City of West Linn PRE-APPLICATION CONFERENCE MEETING Notes November 15, 2012

SUBJECT: Expansion/Alteration of a Non-Conforming Structure (deck) at 2337 Taylor Drive

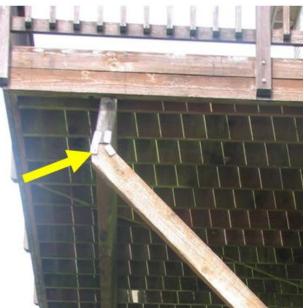
The house at 2337 Taylor Drive was built, circa 1999, with a deck at the rear of the house that stands 25-30 feet above grade. The deck has been in this location for 14 years at no apparent detriment to the adjoining properties or neighborhood. The nearest housing west of the deck is 150 feet away in the Madison Heights Condominiums which are also 75 feet in elevation below the applicant's property and separated by a year round buffer of mature coniferous trees. The residential lots to the north and south are unoccupied.

According to the applicant, the deck's angled columns were either not properly engineered or constructed to support the deck load. Consequently, the deck beams, which extend back into the house, are causing uplifts of the living room floor when people are standing on the deck.

For the Planning Department, there is an additional concern, relative to the Community Development Code (CDC): the deck is within the 20 foot rear yard setback and is above a 20 foot wide sanitary sewer easement. No decks over 30-inches high are allowed in the rear setback and no structures (with exceptions) are allowed to be built on or over easements. For these reasons the deck is classified as a Non-Conforming Structure. In order for the deck to be repaired, a CDC Chapter 66 permit must be obtained to allow continued encroachment into the rear setback.

The applicant has submitted plans showing the angled columns tying back into the house at over 12 feet above grade. If that is accomplished then the easement issue will have been satisfactorily addressed.

The second solution is to have the deck's angled columns at least 12 feet above grade per 38.060(A):

An open deck may extend into an existing utility easement, provided a minimum vertical clearance of 12 feet is maintained between the lowest point of the deck and the ground, and that no posts are installed within the easement. No other structures shall be allowed.
